NorthConnex Application Number: SSI 13_6136

Please find below my submission in response to the exhibition of the EIS for NorthConnex.

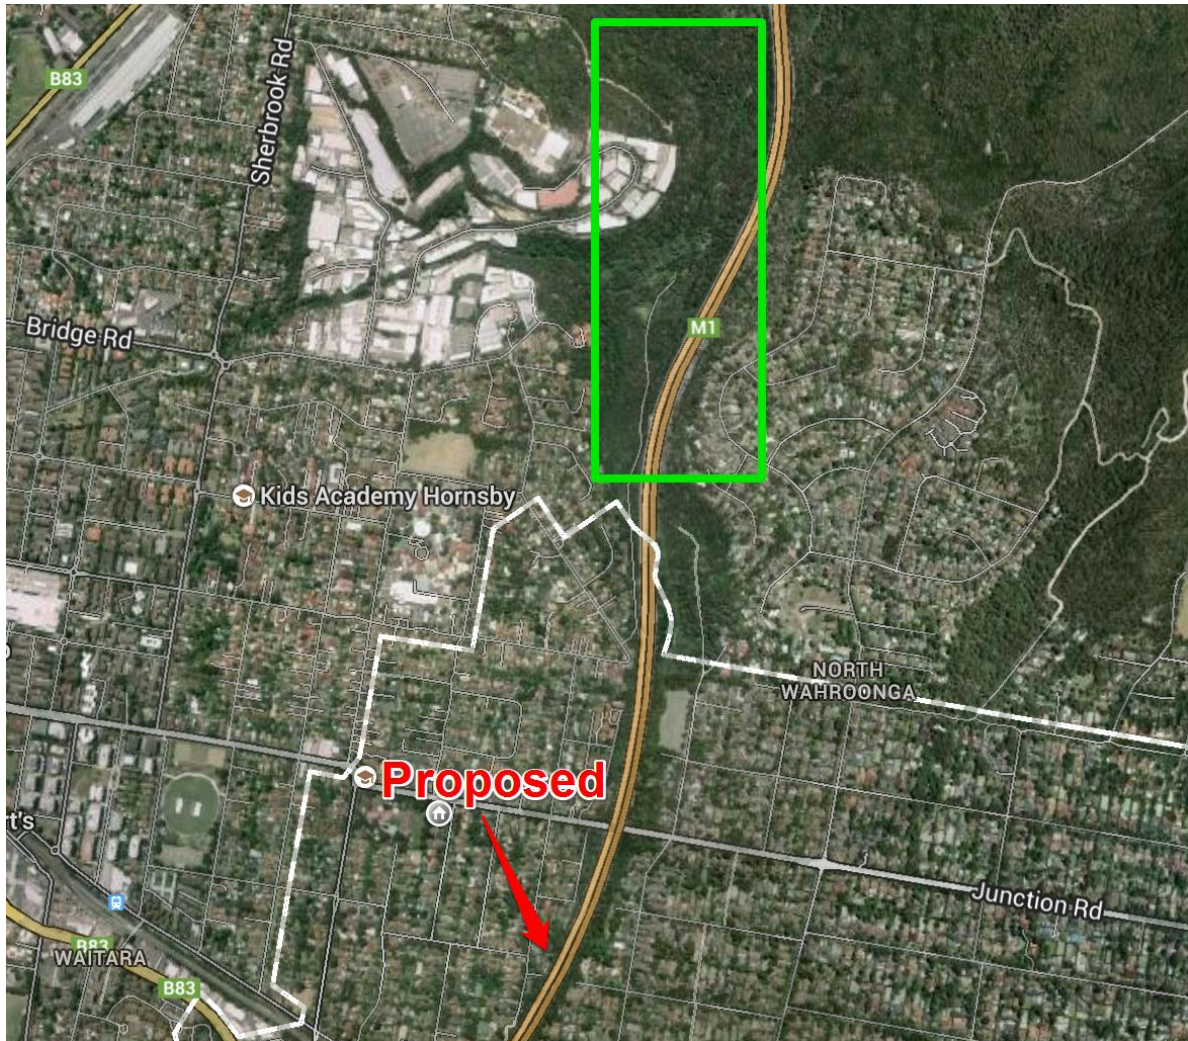
4. The overall length of the proposed tunnel is dangerously long. As well as resulting in super concentrated emissions at two point sources, having a tunnel this long poses an unacceptable risk to drivers and staff when accidents happen. Alternate designs which allow for a series of shorter tunnels with multiple portals and ventilation stacks have not been evaluated. Included is an infographic showing a rough comparison with other projects in Sydney:
